MEMORANDUM

REVIEW TYPE: Preliminary Plan Review

PROJECT NAME: Anselmo Property
CASE #: 120100160

Figure 3

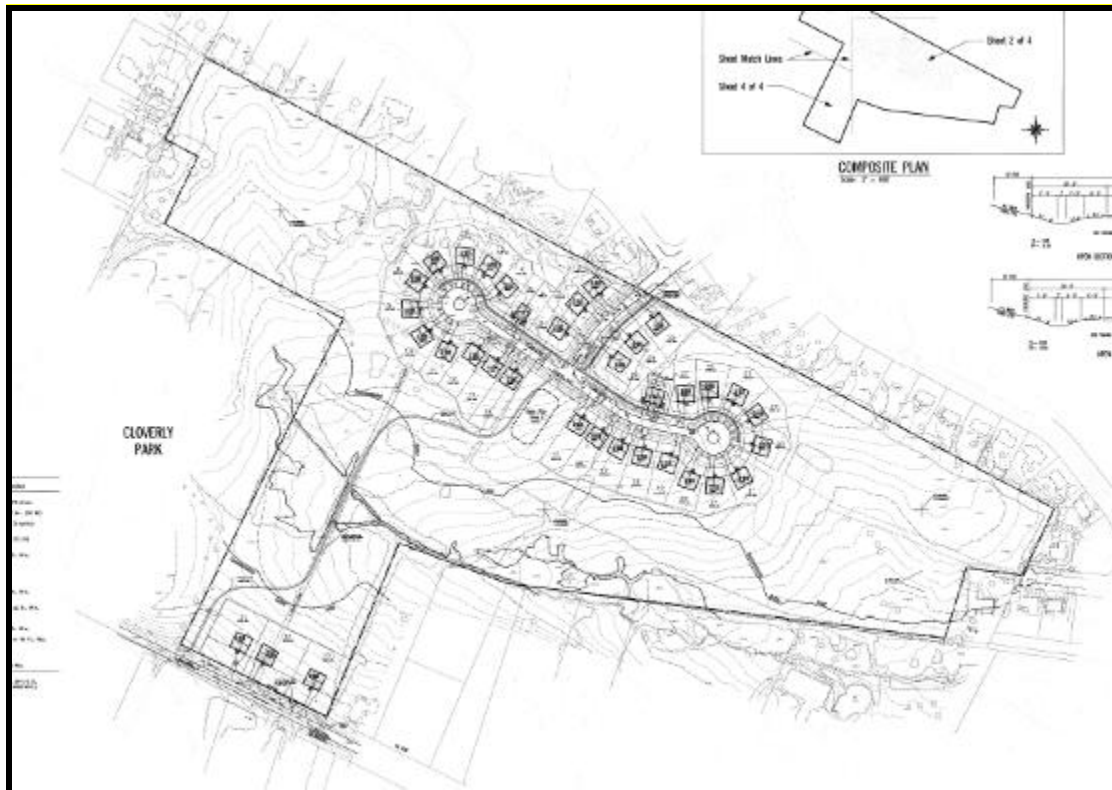
- 1) Staff advises that the calculation of the gross tract area on the Impervious Area Plan correctly includes the land area between the right-of-way /property line and the edge of pavement of Briggs Chaney Road along the Property frontage. However, the calculation of impervious area for the site must include not only the proposed improvements within the right-of-way but also, the existing impervious area, including the existing bikeway/walkway path. The impervious area calculations must be revised to include the entirety of the path.

- 2) At the time of Site Plan, show a 5 foot wide paved pathway leading from Rainbow Drive to Briggs Chaney Road. Staff and the Applicant currently disagree on the width of this important path connection that will serve the neighborhoods to the north. The Preliminary Plan and impervious calculations currently show this as a four foot wide paved path. Staff advises that a five foot wide path is the minimum width that will allow two individuals to walk side by side or pass with ease. This particular pedestrian connection, which was at one time recommended to be an on-street bikepath in conjunction with Rainbow Drive, will carry higher volumes of pedestrians. Staff seeks Planning Board support for a five foot wide configuration. The addition of one foot of pavement will result in more imperviousness and may require reduction of other impervious surface areas.

- 3) Staff recommends that at the time of Site Plan, all driveways less than 80 feet in length measured from the street line to the garage door, be constructed at double-width for the entirety of their length. This recommendation is based on Planning Board action for similar applications in Special Protection Areas where staff made this recommendation based on past experience revealing that owners of driveways less than 80 feet are likely to widen them to improve vehicular parking and circulation, thereby increasing the imperviousness the Board was trying to achieve. Staff believes it appropriate to account for the likelihood of this occurrence when impervious limits are set at the regulatory review stage.

As discussed in the Issues section of this report, it appears that the imperviousness for the subdivision as currently shown on the preliminary plan would be in excess of 8 % for the subdivision. The Impervious Area Plan that was submitted on October 6, 2010 contains an error. The calculation of the gross tract area correctly includes the land area between the right-of-way line and the edge of pavement along the property's frontage on Briggs Chaney Road. However, the calculation of impervious area for the site must include the existing impervious area within the right-of-way, which includes the existing bikeway/walkway path. The impervious area calculations must be revised to include the path.

Staff also recommends that the plan adhere to staff and Board policy regarding the configuration of driveways within areas of the County that are held to impervious limitations. As shown on the Preliminary Plan, the driveways are double-width where they meet the house/garage but then taper down to single-width driveways as they reach the street. While this design may serve to minimize impervious area in theory, it is staff's experience that if the overall length of the driveway is too short, it does not allow for an adequate area for cars to maneuver around each other when entering/exiting the driveway. This situation often results in individual homeowners adding additional pavement to their driveway after the builder has left the project. Homeowners tend to add pavement to create a uniform width for the entire length of the driveway, thereby increasing the impervious area on the property. Based on staff investigation, the widening of driveways to accommodate additional cars and to improve circulation is prevalent.
